ADDENDUM NUMBER FOUR (004)

DATE: June 10, 2025

PROJECT: **Caribou Police Facility**

PROJECT NUMBER: Artifex Project No. 2023102

Figure 1

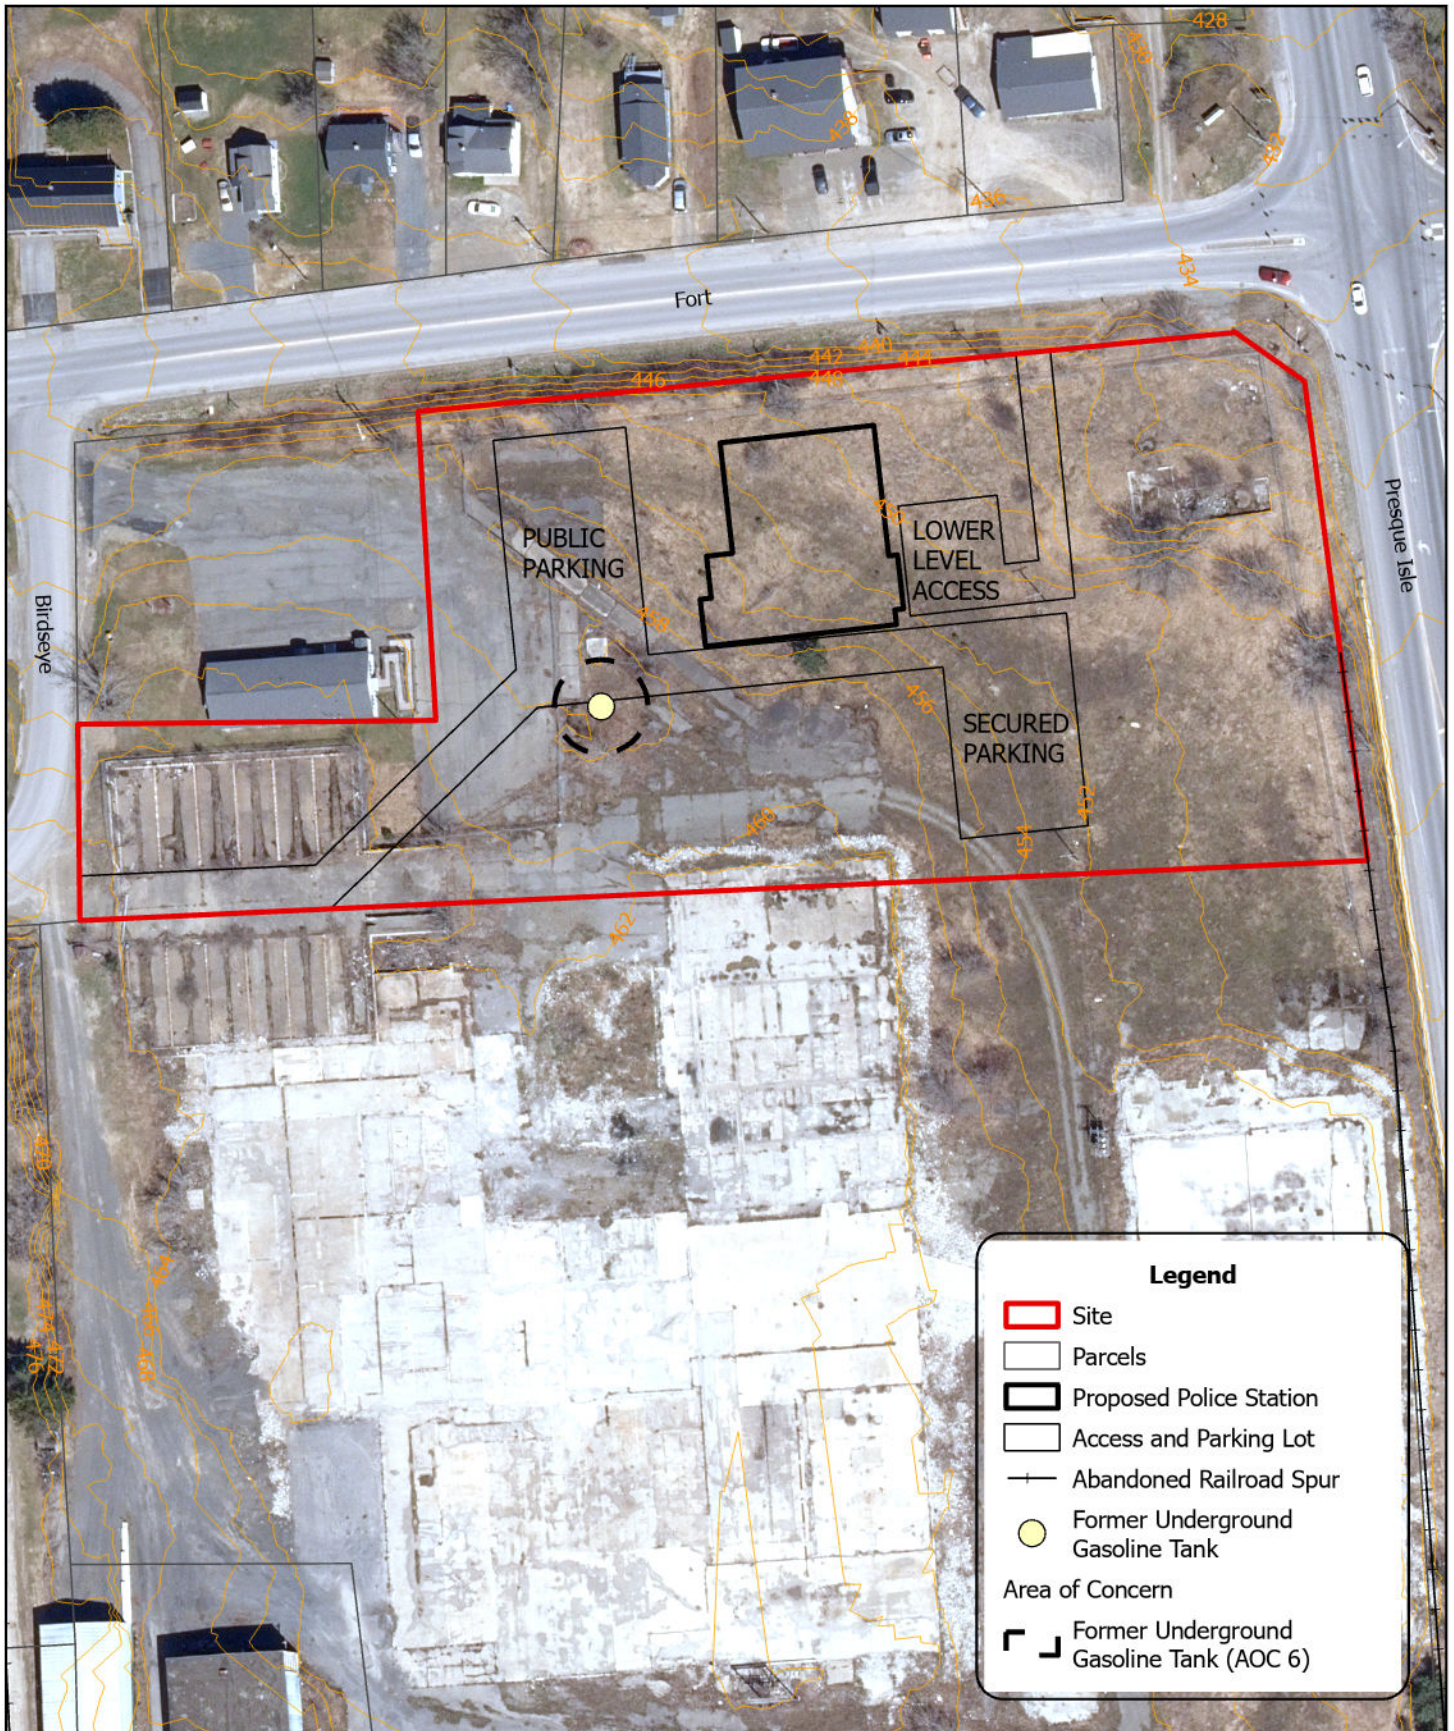
As illustrated on the attached Site Map (Figure 1), the area of concern (AOC) at the subject property is the former underground storage tank location south of the truck scales on the west side of the property, identified as AOC 6 in the 2014 Phase II ESA.
